NESTLE PURINA WASTEWATER TREATMENT UPGRADES
MAJOR PLAN 2021-102
ATTACHMENTS

TO: PLANNING COMMISSION
FROM: GREGG ADAMS, PLANNER
SUBJECT: NESTLE PURINA WASTEWATER TREATMENT UPGRADES
MAJOR PLAN 2021-102
REQUEST FOR PRELIMINARY/FINAL PLAN REVIEW
DATE: APRIL 12, 2021
COPIES: BOARD OF COMMISSIONERS, T. PETRUCCI, H. BENDER,
D.HARRIER, J.. HARRIER, J. ZATOR, ESQ., J. ADLERFER, ESQ.,
S. PIDCOCK, APPLICANT, SUB. FILE 2021-102

SUBJECT: South Whitehall Township
Nestle Wastewater Treatment Upgrades
Major Subdivision #2021-102
Preliminary/Final Plan Review

RE: Geotechnical Engineering Review of
Provided Documents
Nestle Wastewater Treatment System Upgrade
Major Sketch Plan 2021-102
South Whitehall Township, Lehigh County,
Pennsylvania
Hanover Project SWT21-11(004)

DATE	11/16/2023	EXISTING FEATURES PLAN 2	PLANT
MADE BY	JAZ	WASTEWATER TREATMENT UPGRADES	BLDG. NO.
SCALE	1" = 50'		AREA NO.
APPROVED BY	CJW	SOUTH WHITEHALL TOWNSHIP	DRAWING NUMBER
PRINTED	CJW	LEHIGH COUNTY	671-C405
		PENNSYLVANIA	REVISION
			A

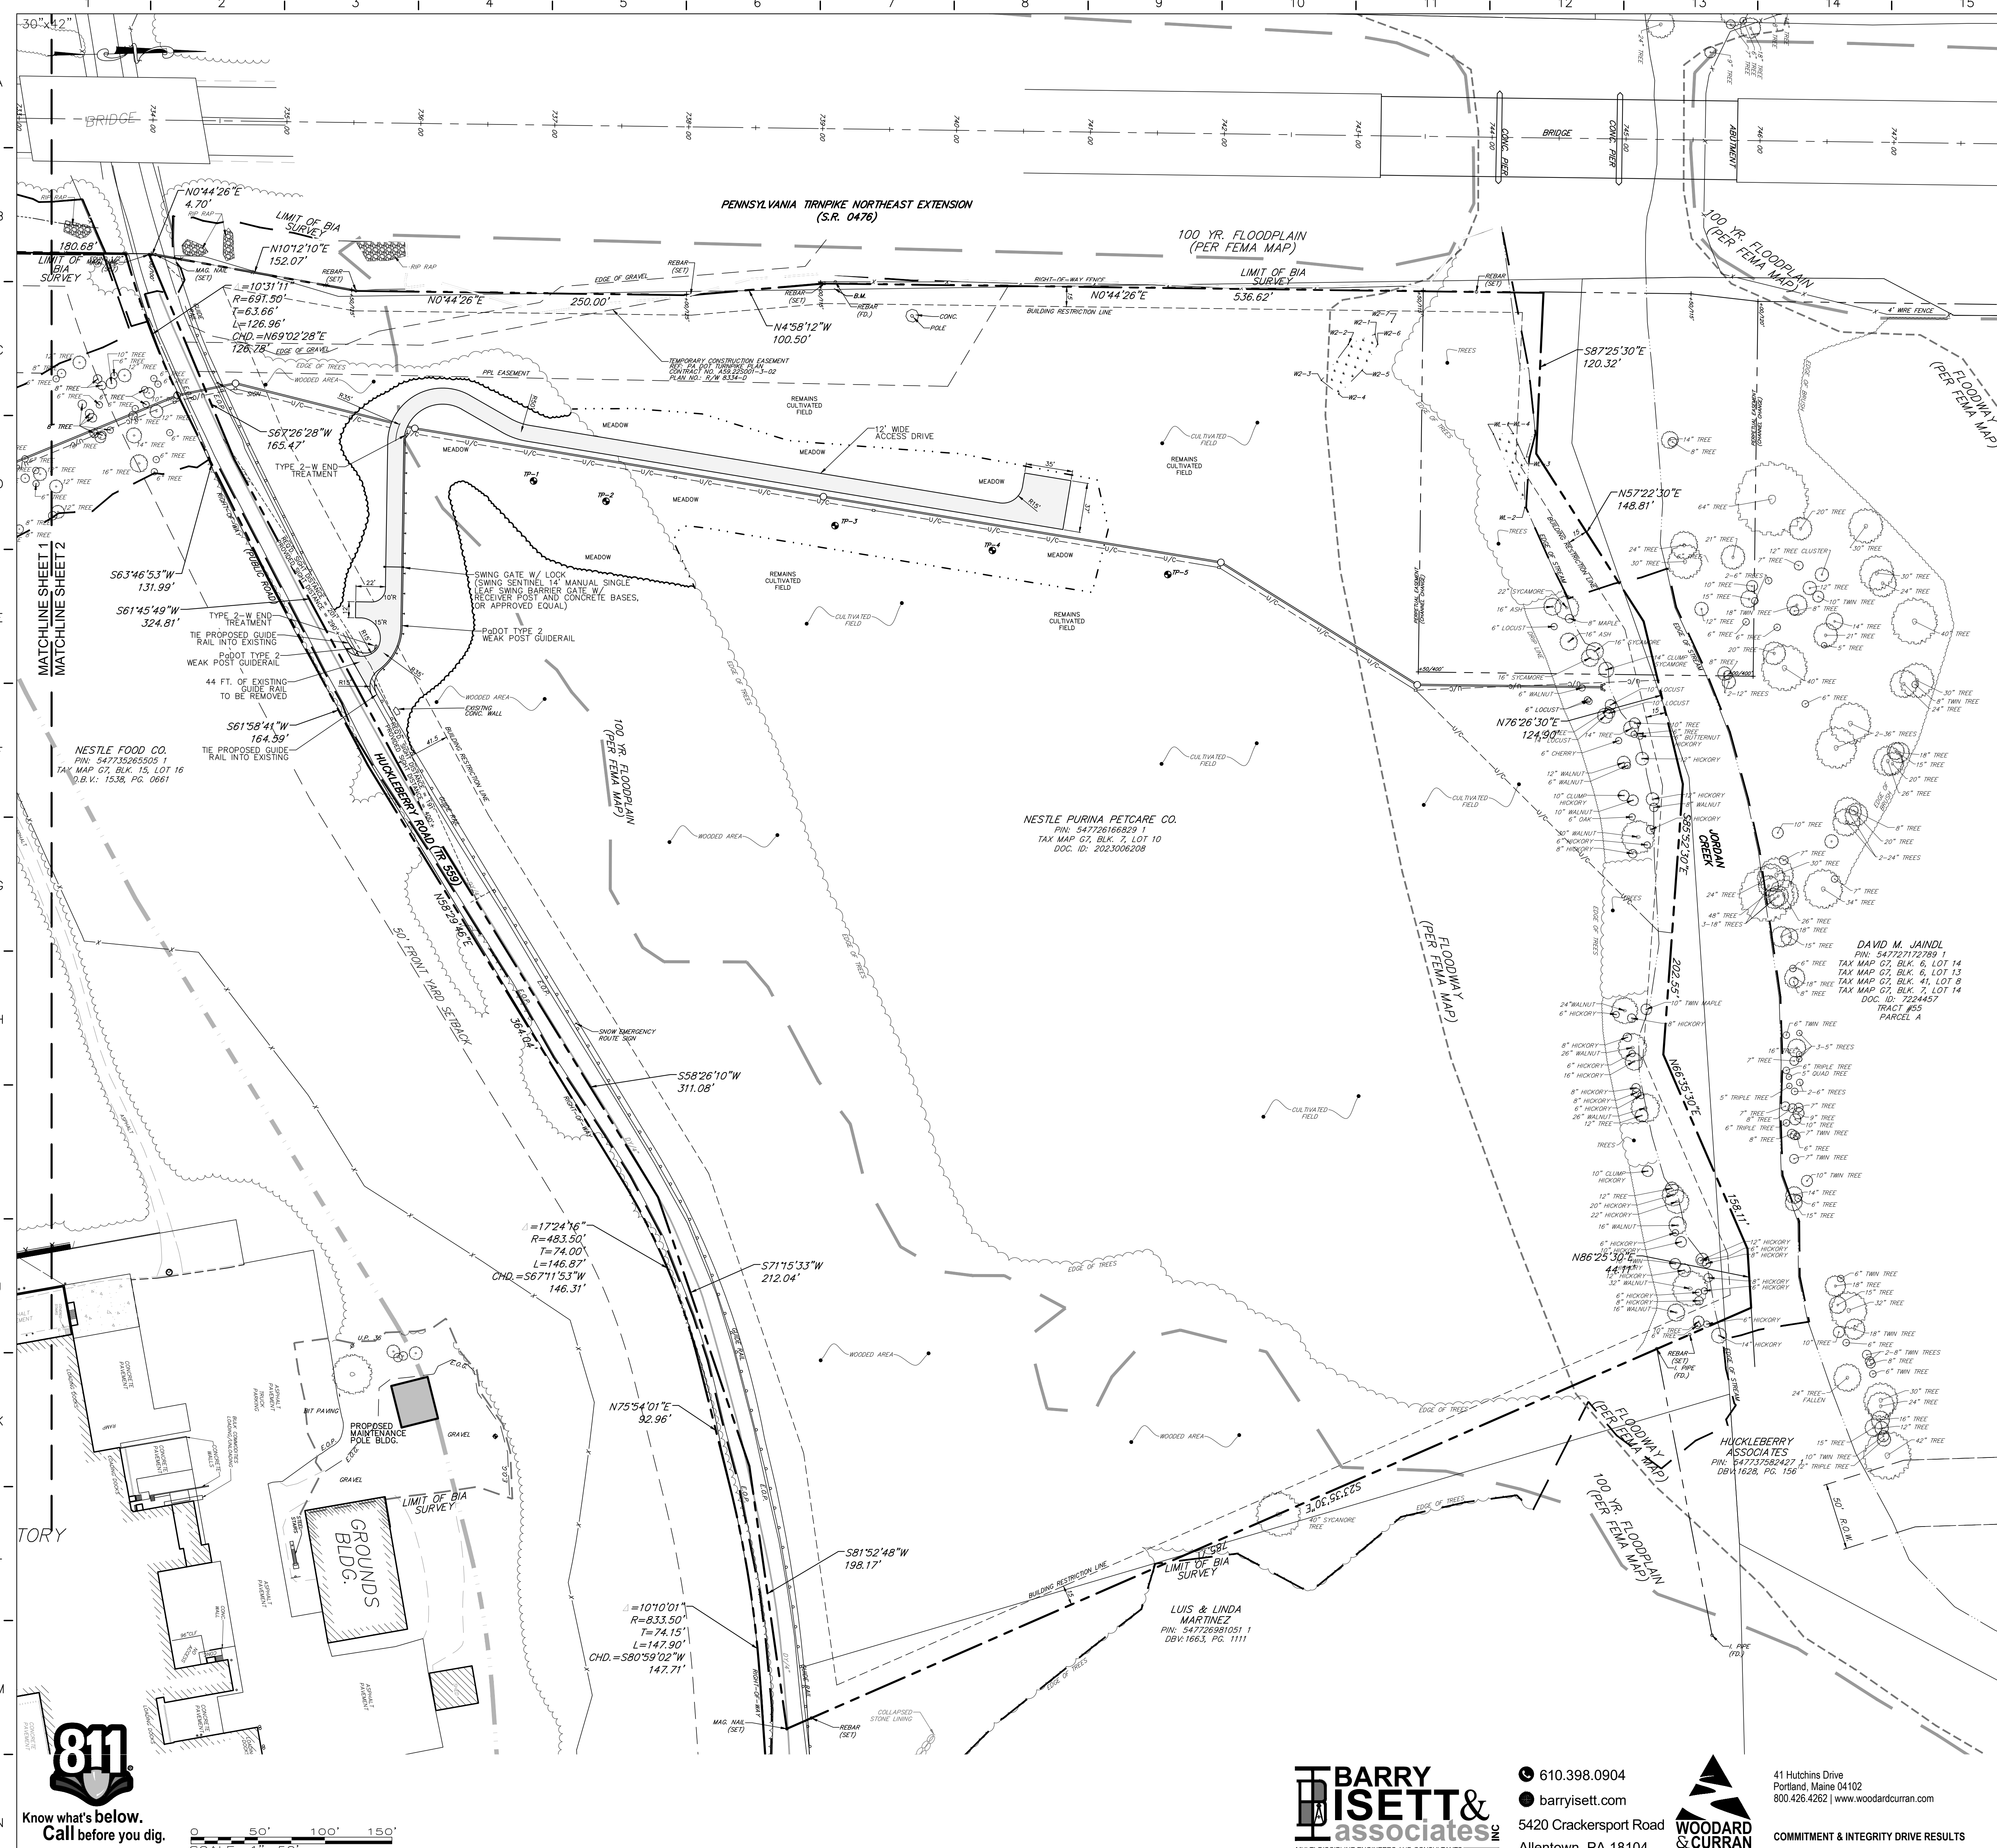
2. On Sheet 671-C405, multiple points are shown and labeled as "rock probe". The data obtained from these probes shall be provided to this office for review.
